**RE: All-Rite Construction Warehouse
519 Oliver Ross Dr. NW
Grading & Drainage Plan
Engineer's Stamp Date: 05/15/20
Hydrology File: K09D042**

Based upon the information provided in your resubmittal received 05/27/2020, the Grading & Drainage Plan is approved for Building Permit.

GRADING &
DRAINAGE
PLAN

C-101

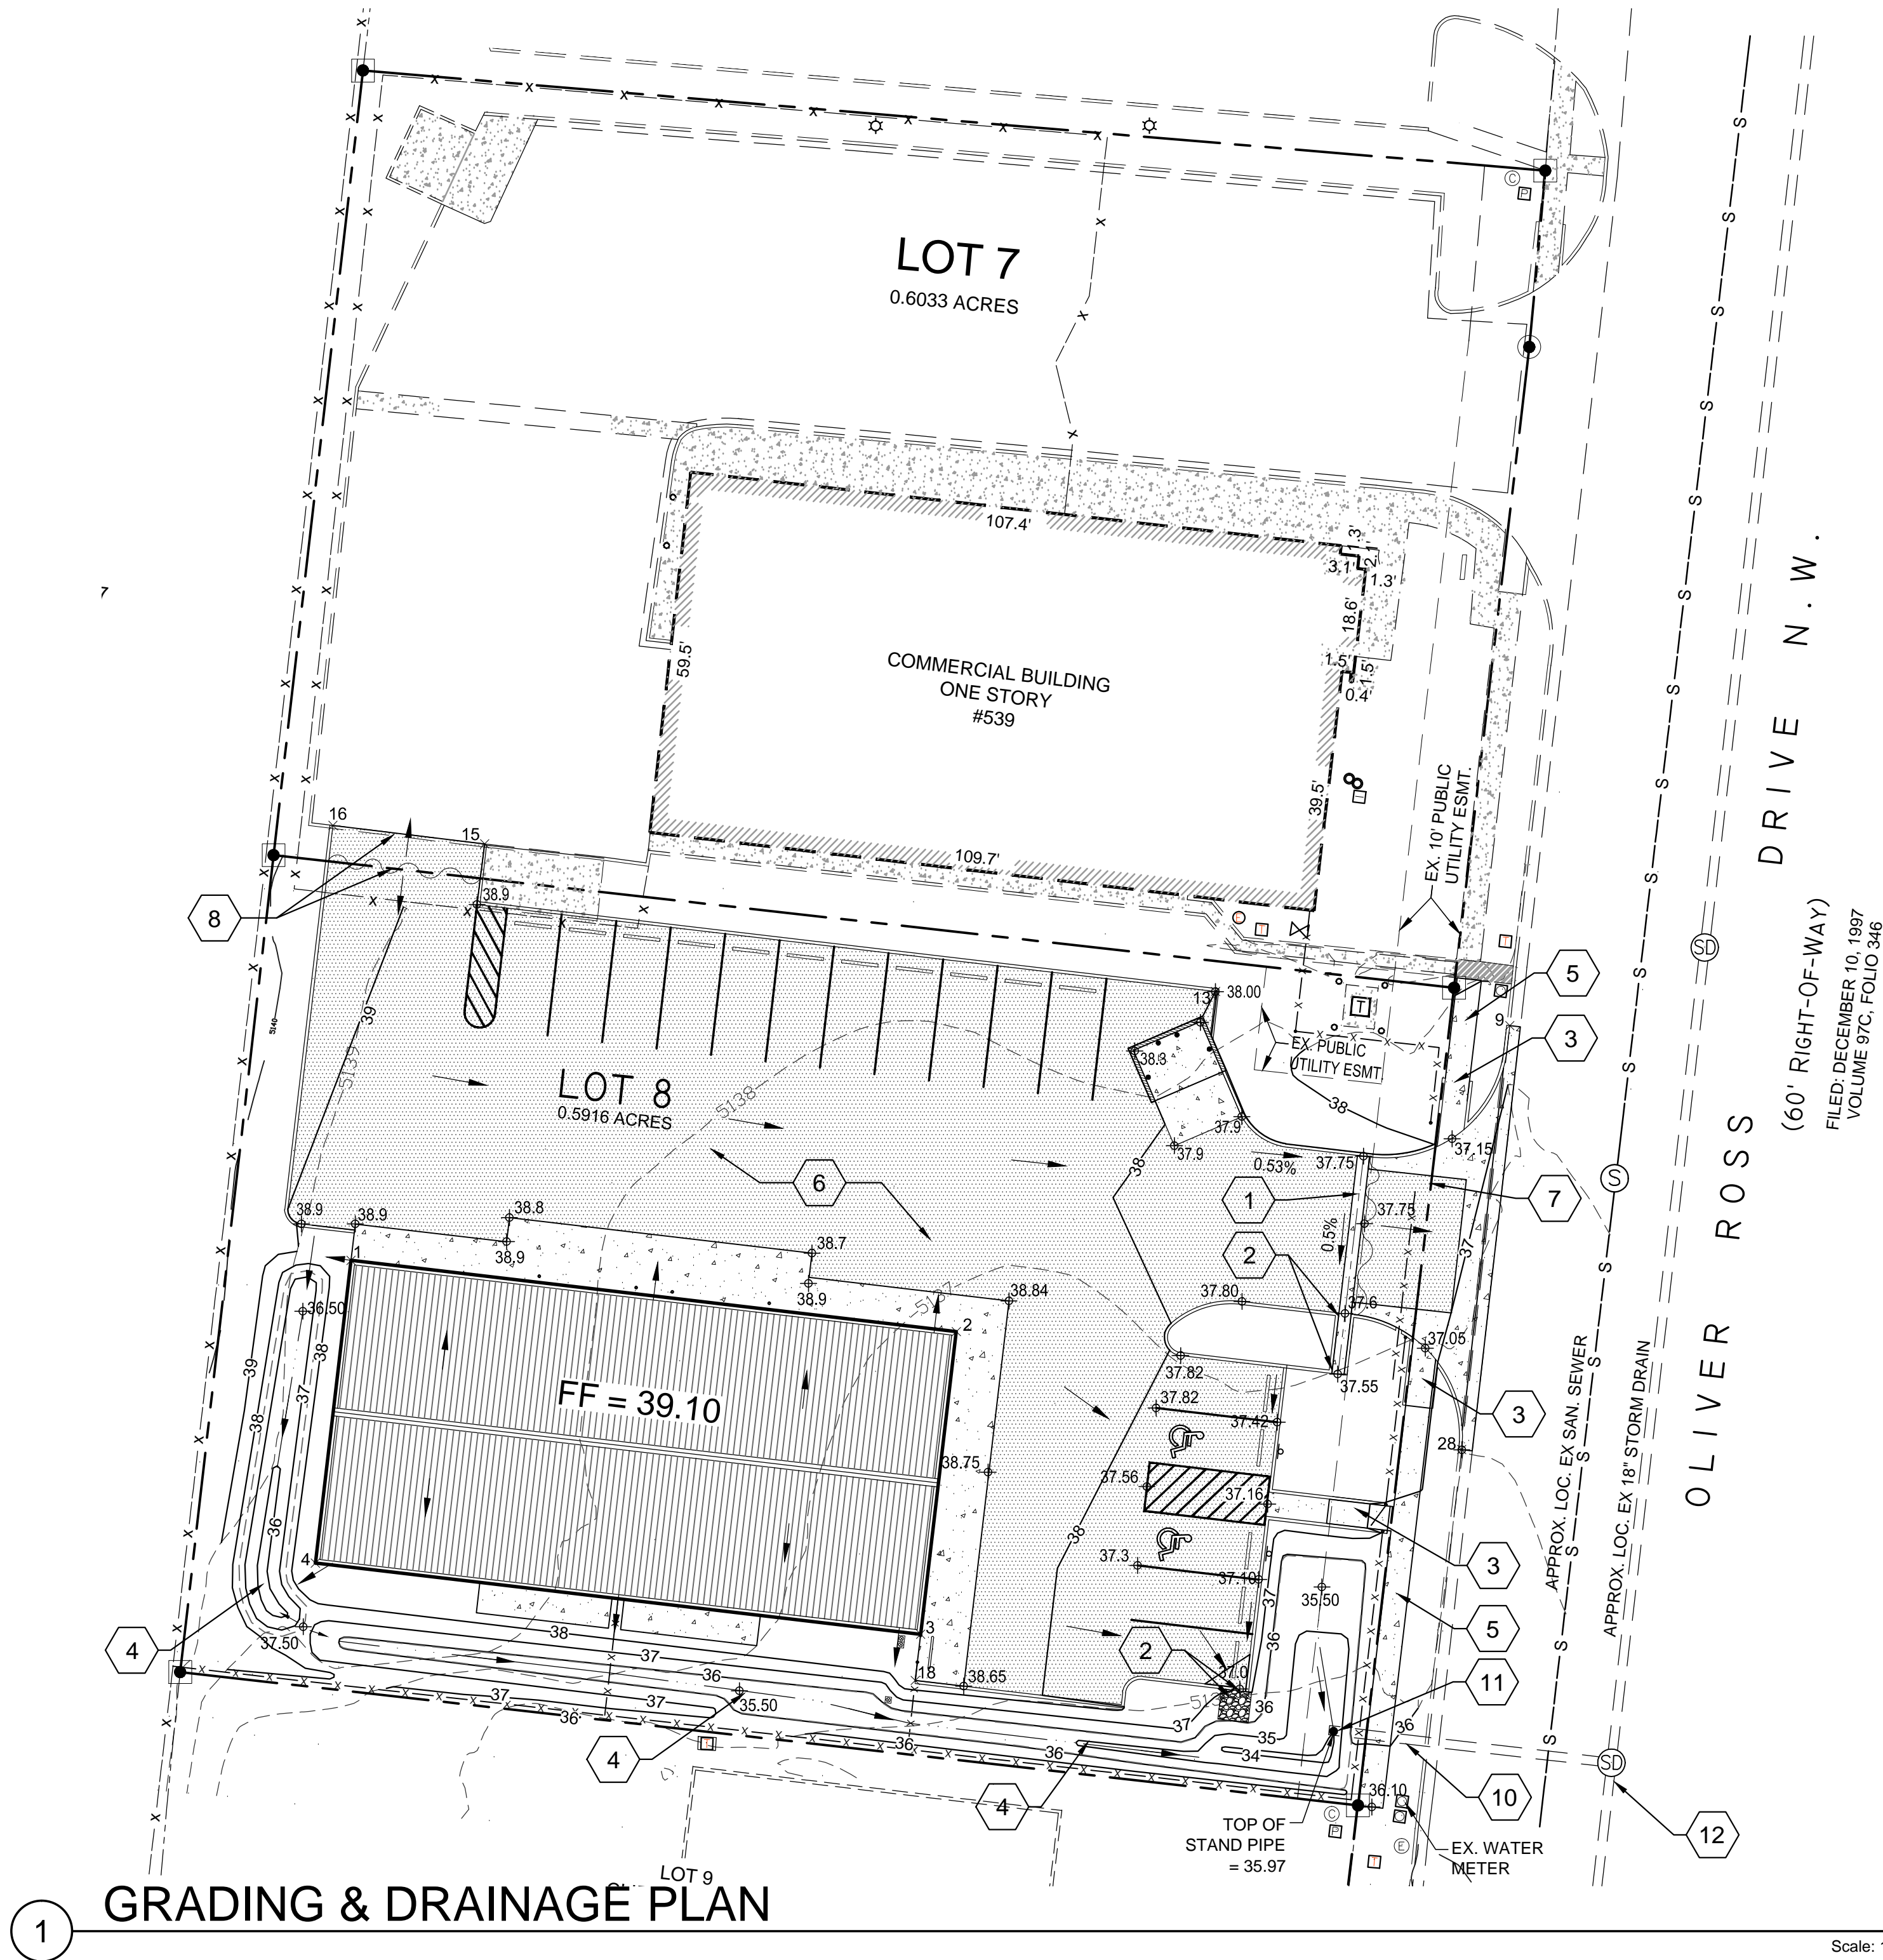
Please attach a copy of this approved plan in the construction sets for Building Permit processing along with a copy of this letter. Prior to approval in support of Permanent Release of Occupancy by Hydrology, Engineer Certification per the DPM checklist will be required.

Also as a reminder, please provide Drainage Covenant for the detention pond per Chapter 17 of the DPM prior to Permanent Release of Occupancy. Please submit this on the 4th floor of Plaza de Sol. A \$25 fee will be required.
